UNITED STATES PATENT AND TRADEMARK OFFICE

10/776,851

| Office Action Summary | Application No. 10/776,851 | Applicant(s) BECKER ET AL. | |

DETAILED ACTION

FIG. 2

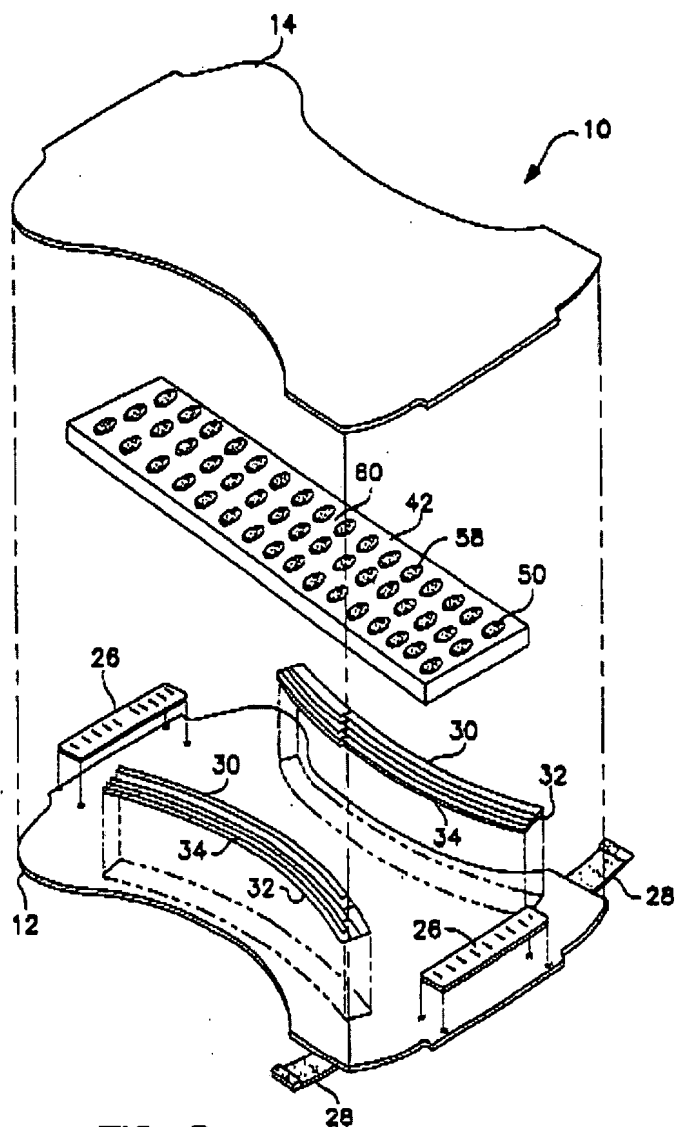
Regarding claims 1 and 13, Tanzer teaches a disposable diaper (10) comprising:

A chassis including a liquid impervious backsheet (12) and a liquid pervious topsheet (14); and

An absorbent core (42, 58) located between said backsheet (12) and said topsheet (14) which includes first and second substrate layers (42) each having absorbent material (58)

3deposited thereon, said absorbent material (58) comprising an absorbent polymer material and optionally an absorbent fibrous material, said absorbent fibrous material not representing more than about 20 % of the weight of absorbent polymer material, wherein said absorbent material (58) is immobilized (trapped in pockets (50)) when wet such that said absorbent core (42, 50, 58) achieves a wet immobilization (liquid is immobilized in the pockets (50) by the superabsorbent (58))(page 6, line 8-page 8, line 2)(see fig. 2, *infra*).
